QUALITY ASSURANCE -- NON-CONFORMANCE REPORT

Report No: NCR-000714

Reference Description: Missed MT transverse indications by QC on Segment 7CE Bottom Panel to T-Rib

Job Name: SAS Superstructure

Joint fit-up Coating Other Component: Segment 7CE Bottom Panel to T-Rib

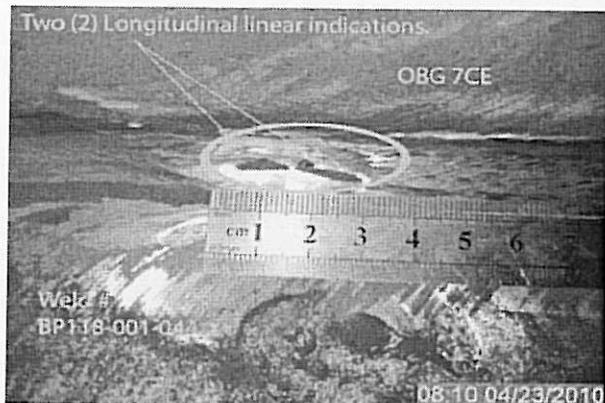
During the Quality Assurance (QA) Magnetic Particle Testing (MT) review of welds located on OBG Segment 7CE, this QA Inspector discovered the following issues:

- Two (2) Longitudinal linear indications in the hold back weld between "T" Rib and Bottom panel.
- The longitudinal linear indications are located at Y locations 260mm and 277mm when measured from the end of the hold back fillet weld.
- The weld designation is BP118-001-044.
- The rib stiffener is identified as RSB24F.
- The indications are clearly marked on or near the weld.
- Length of indications measured approximately 14mm and 12mm.
- The OBG segment 7CE is located in the trial assembly.
- The Notice of Witness Inspection (NWIT) No. is 005581. The indications are located in an area previously tested and accepted by ZPMC Quality Control (QC) personnel.

AWS D1.5 (02) Section 6.26.2 – “Welds that are subject to MT in addition to visual inspection shall have no cracks.

Remove indications by grinding and perform NDT required to verify weld quality.

Contractor submitted NDT record verifying indications were successfully removed by grinding.
